DA-B DRAWINGS AMENDED AS SHOWN CLOUDED 29/01/2018 Y T AHM DA-A ISSUED FOR DEVELOPMENT APPLICATION 03/08/2017 Y T **AMENDMENT**

MIXED USE DEVELOPMENT 4-14 Mark St Lidcombe, NSW 2141

**REVISION B:** - Fire stairs relocated to north eastern corner

Basement 3 Plan DESIGNED: DRAWN: COMMENCED: SCALE: PRINT: 1:125@A1 A3 SHEET 1:250@A3

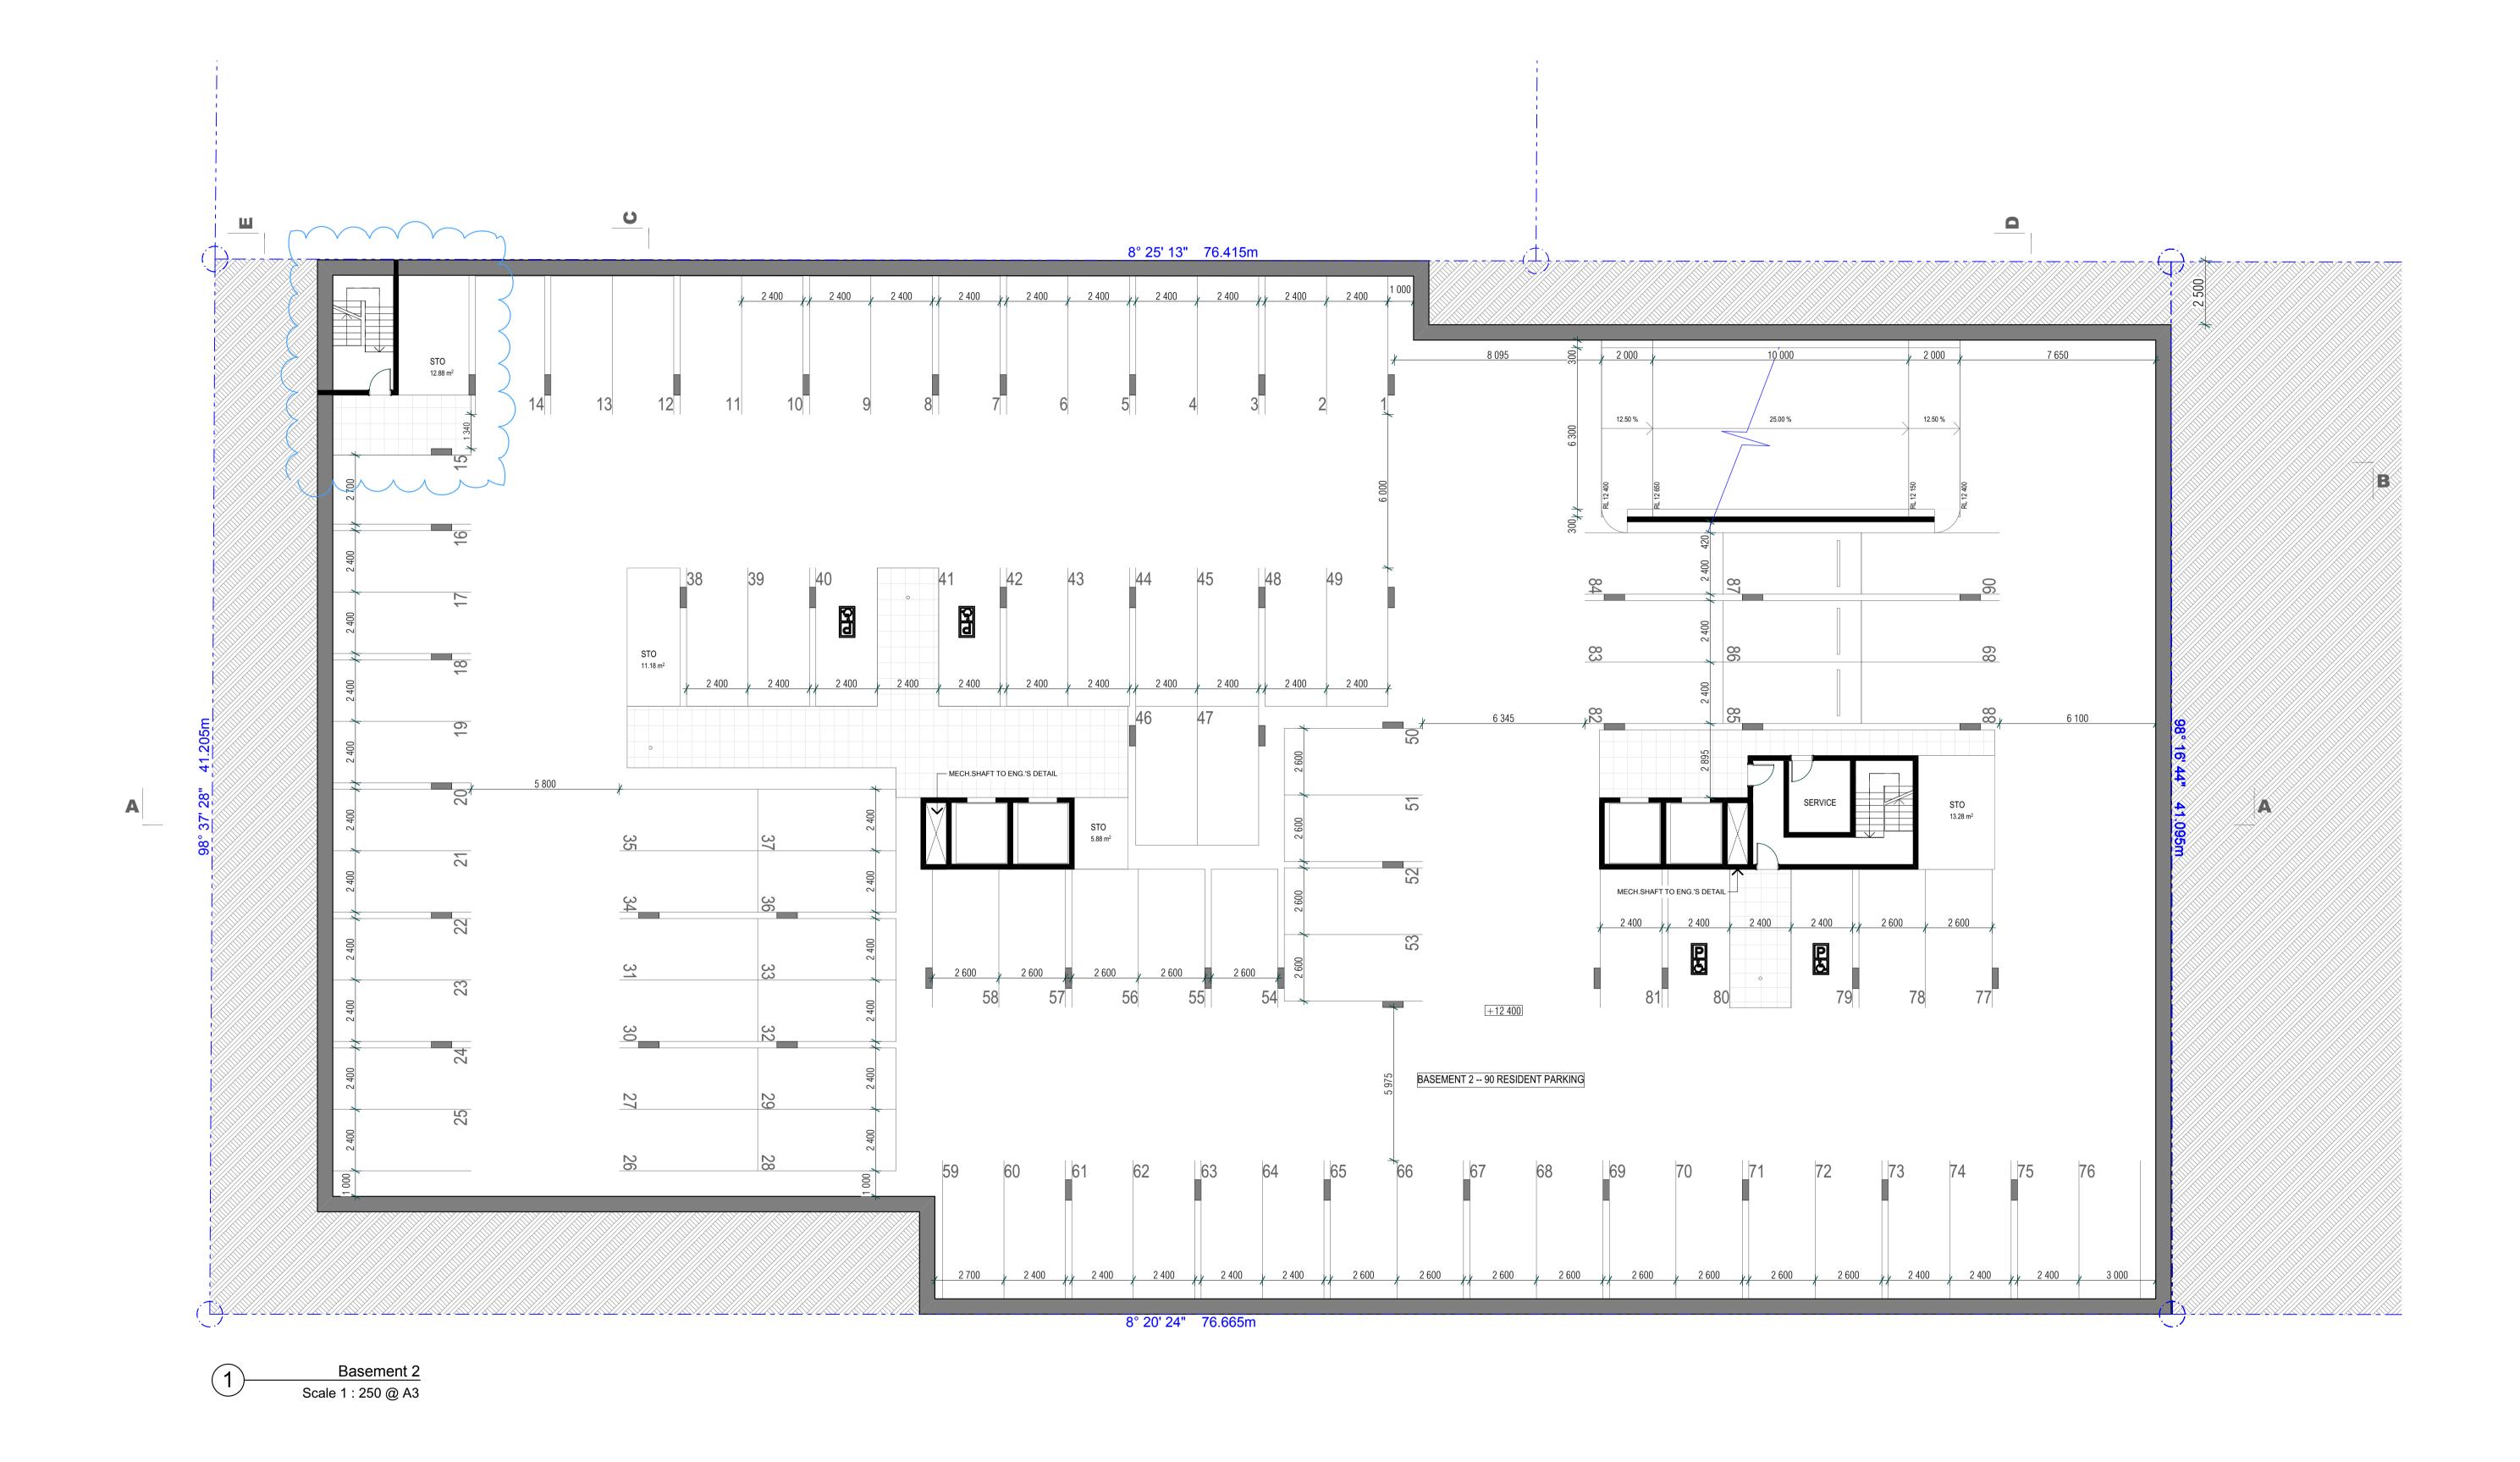
- Fire stairs relocated to north eastern corner

Basement 2 Plan

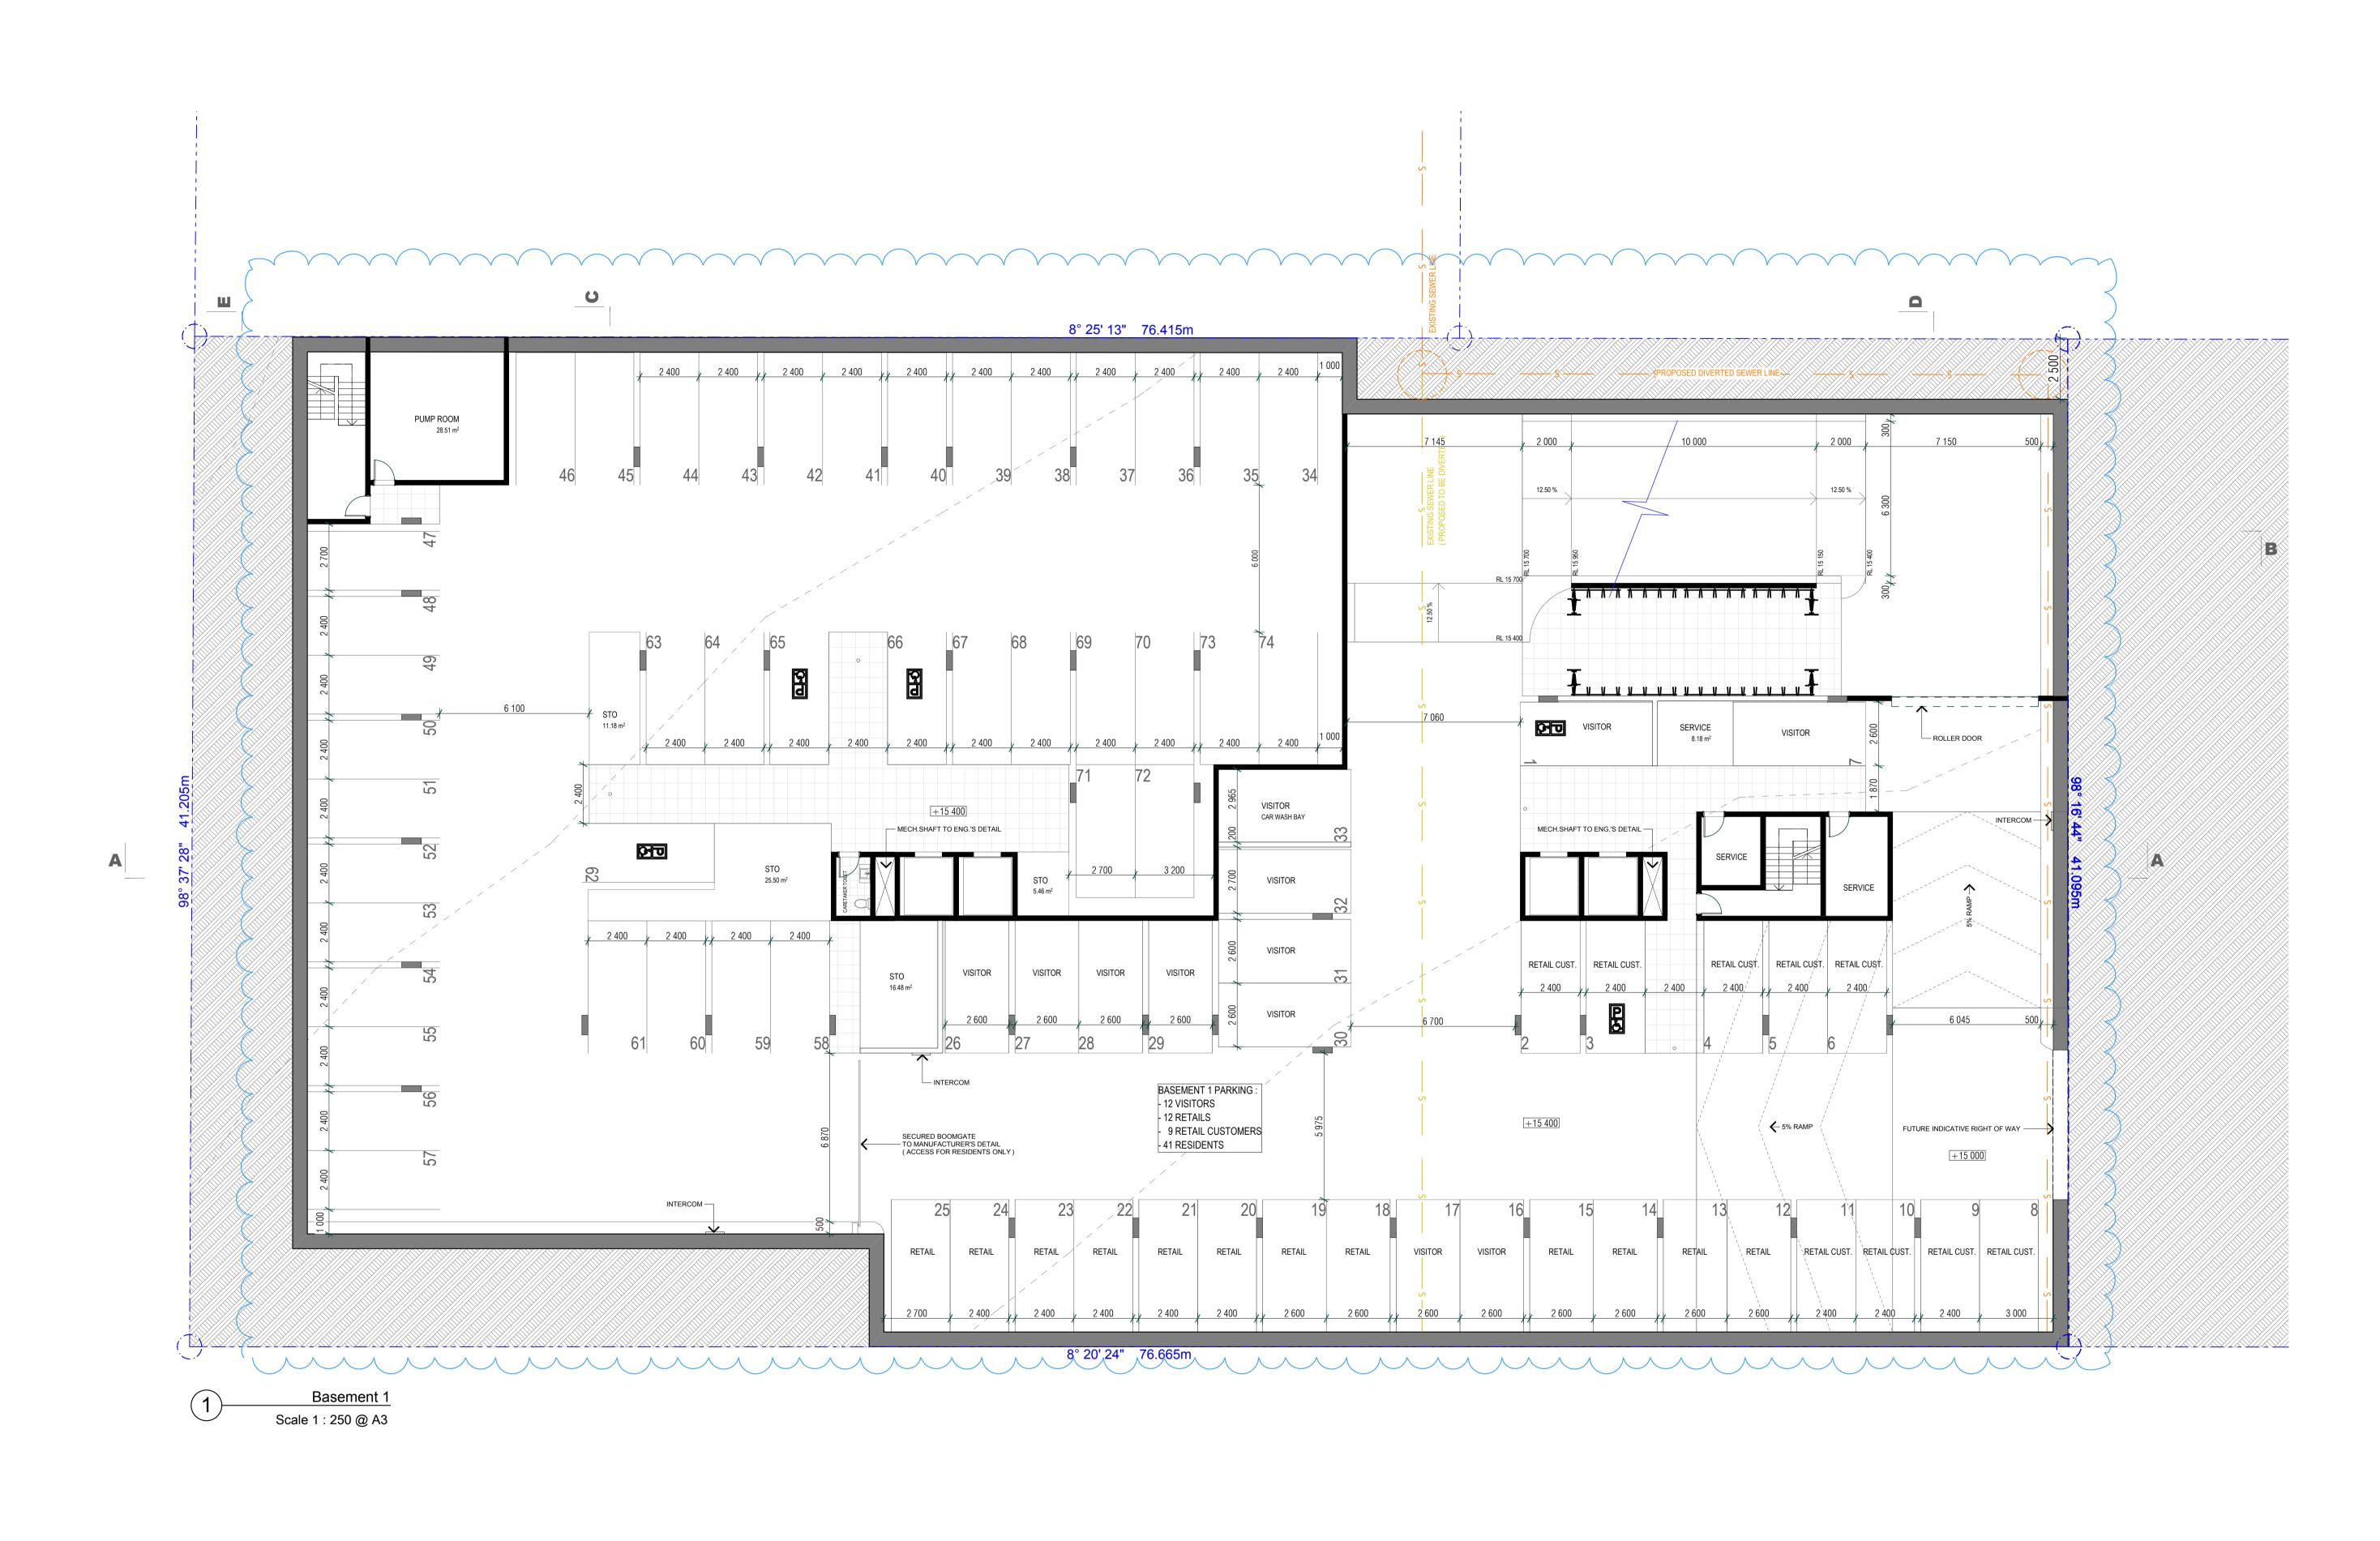
**REVISION B:** - Fire stairs relocated to north eastern corner

Basement 1 Plan

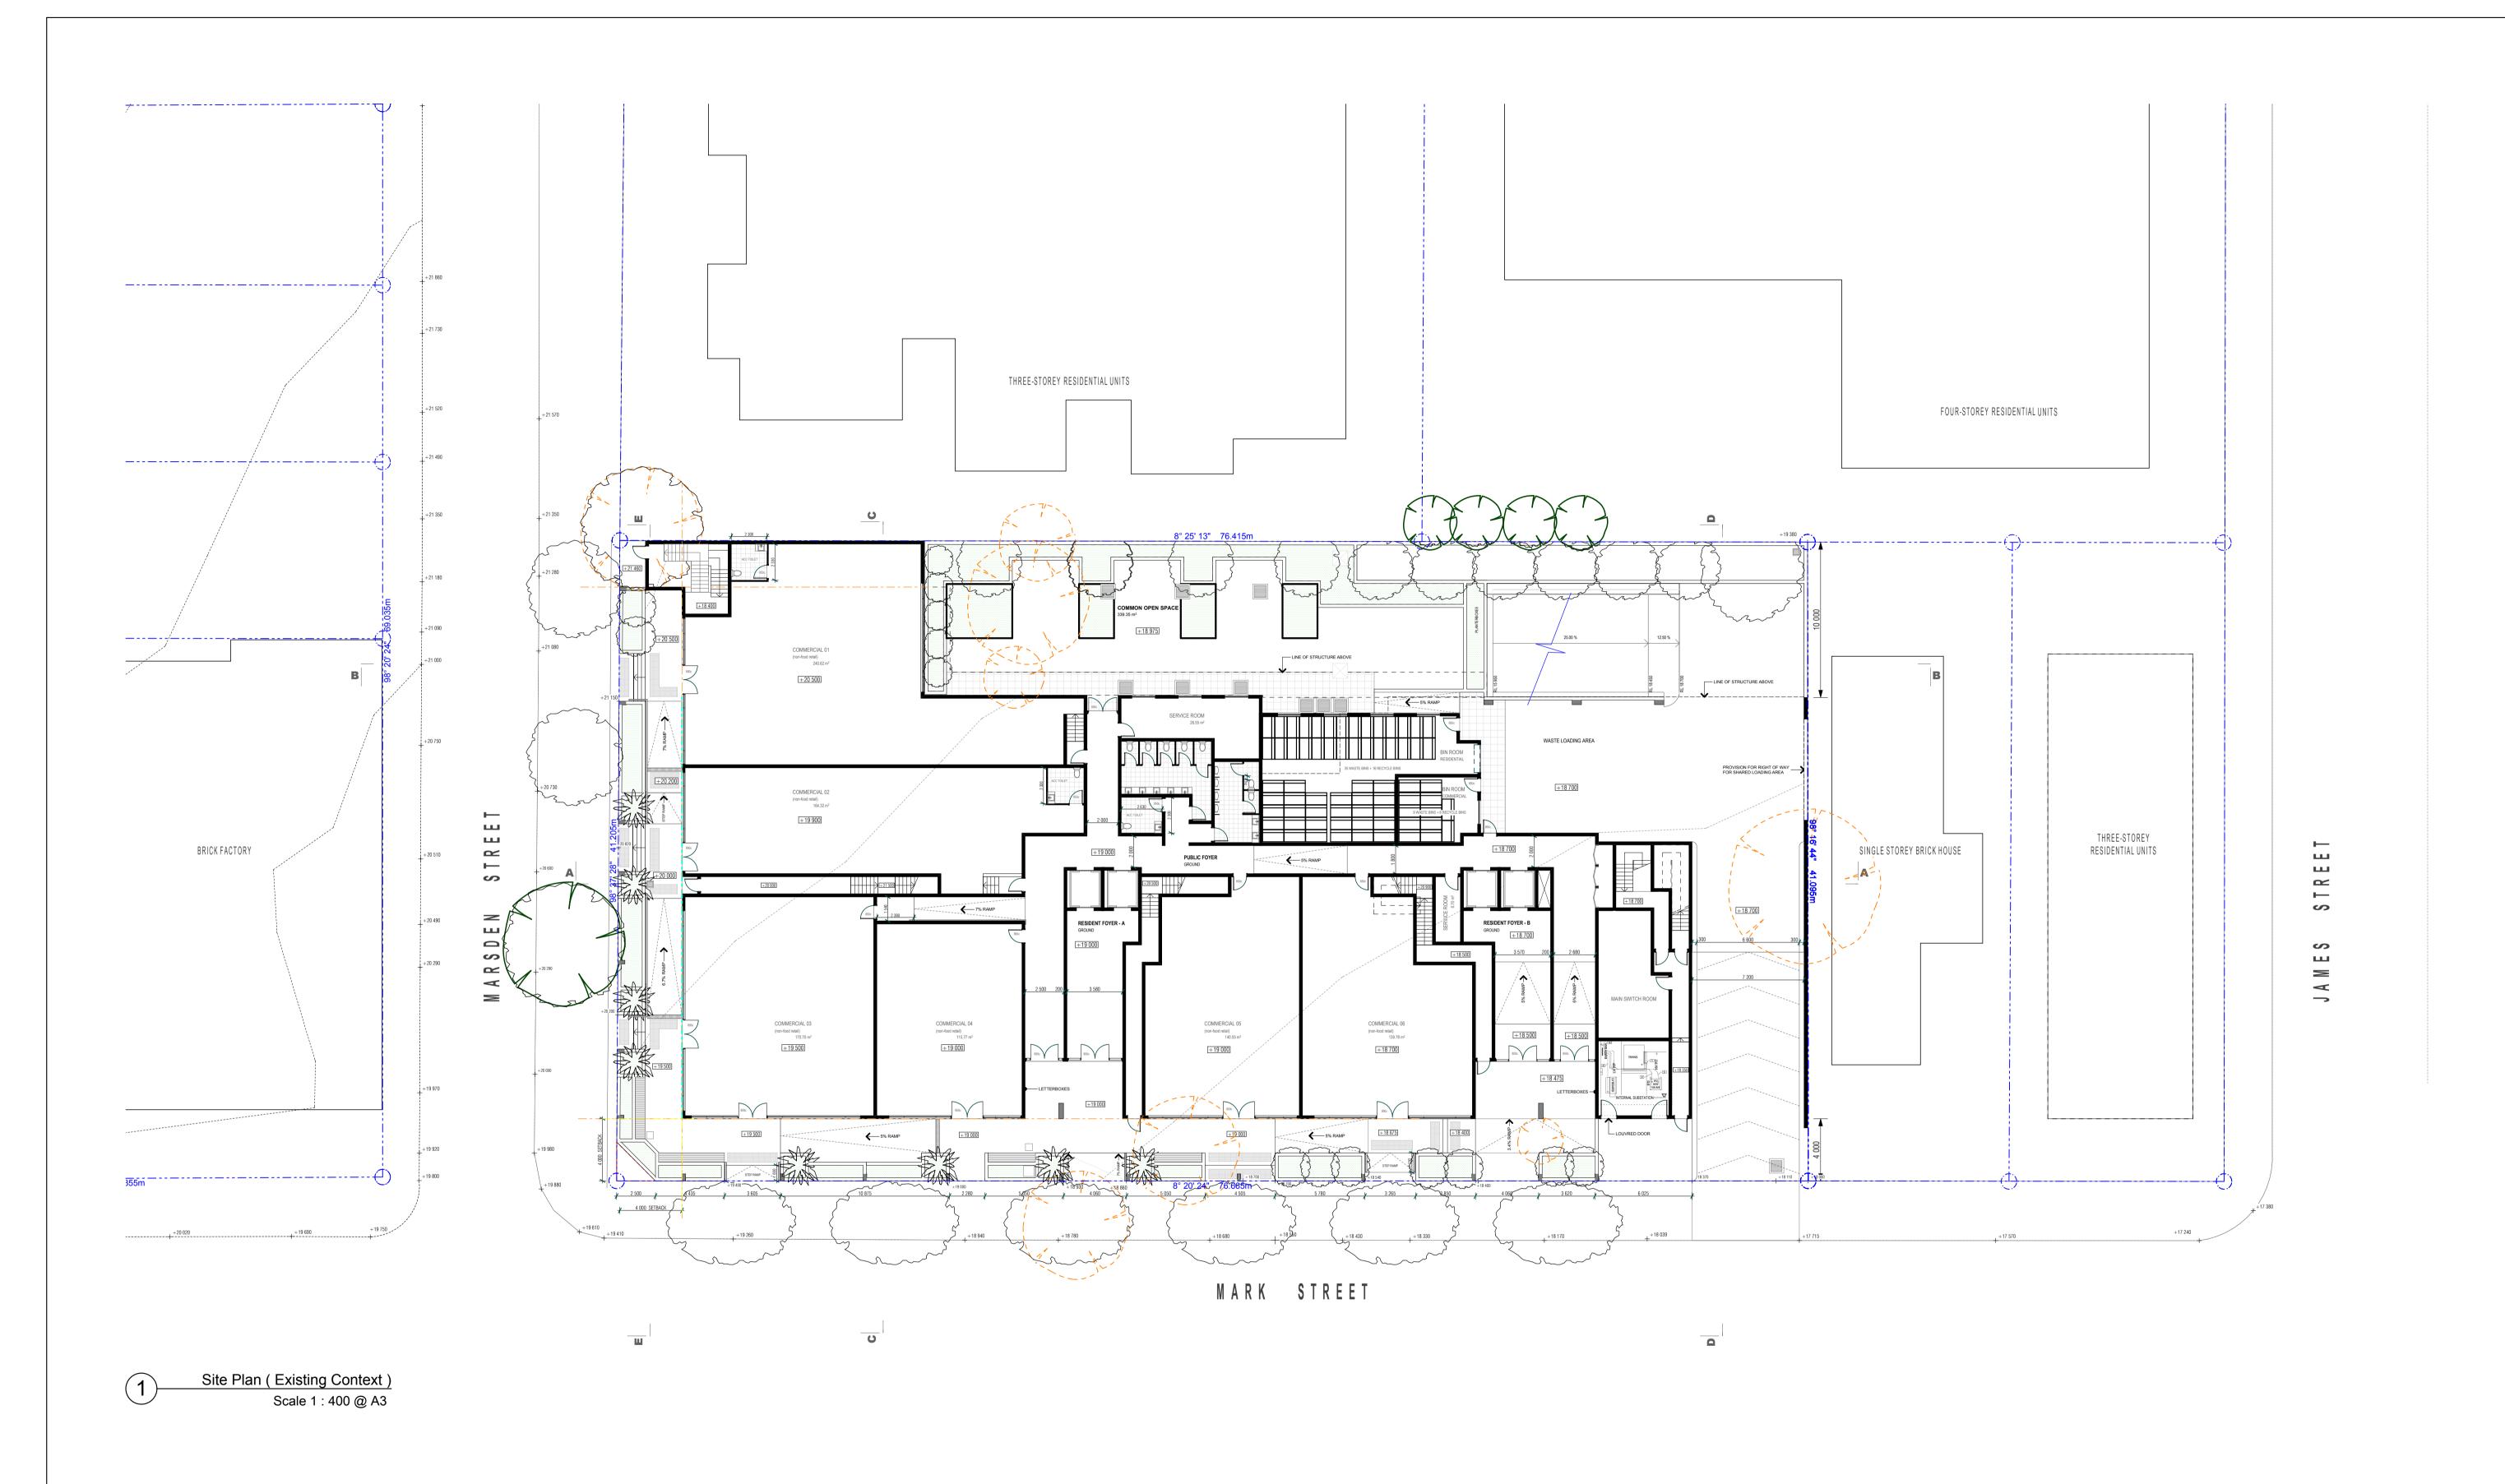
REVISION B : - Basement 1 layout amended to separate public and private parkings - Fire stairs relocated to north eastern corner
